Access Compliance Report

Public Rights-of-Way

(Curb Ramps)

Intersection ID: 11431	Main Street: N_GRAHAM_ST	Cross Street: W_9TH_ST	Location:	S
ADA ID: 3E08A6F7AEA8	Ramp Type: PerpDiag	Initial Pass/Fail: Fail	Overall Compliance: No	Severity Score: 25
Codes/Mitigation Info/Possible Solution		Field Measurements/Component Compliance

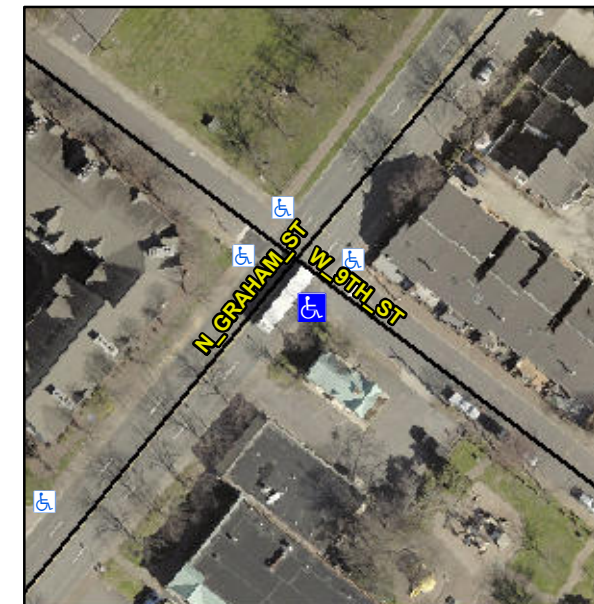
Not Found, R304.2.2

Compliance	Description	Data	Compliance	Description	Data
N/A	Ramp Length (in)	40.0	No	Ramp Slope (%)	12.5
Yes	Ramp Width (in)	48.0	Yes	Ramp XSlope (%)	1.1
N/A	Flare Type LT	N/A	N/A	Flare Type RT	N/A
N/A	Flare Slope LT (%)	N/A	N/A	Flare Slope RT (%)	N/A
N/A	Flare Traversable LT?	N/A	N/A	Flare Traversable RT?	N/A
N/A	Landing Length (in)	N/A	N/A	DWS Provided?	N/A
N/A	Landing Width (in)	N/A	N/A	DWS Contrast?	N/A
N/A	Landing Slope (%)	N/A	N/A	DWS Length (in)	N/A
N/A	Landing X Slope (%)	N/A	N/A	DWS Full Width?	N/A
N/A	Landing Curb? (Y/N)	N/A	N/A	DWS Offset (in)	N/A
N/A	Shared Landing?	N/A			
N/A	Gutter Ponding?	N/A	N/A	Gutter Slope (%)	N/A
N/A	Gutter Lip Ht (in)	N/A	N/A	Gutter X Slope (%)	N/A
N/A	Painted X Walk1?	No	N/A	Painted X Walk2?	No
	X Walk 1 Direction	To NE		X Walk 2 Direction	To NW
N/A	X Walk 1 Width (in)	N/A	N/A	X Walk 2 Width (in)	N/A
	X Walk 1 Slope (%)	4.1		X Walk 2 Slope (%)	0.8
	X Walk 1 X Slope (%)	2.0		X Walk 2 X Slope (%)	0.2

Remove & Replace Curb Ramp With Two New Directional Ramps or Equivalent.
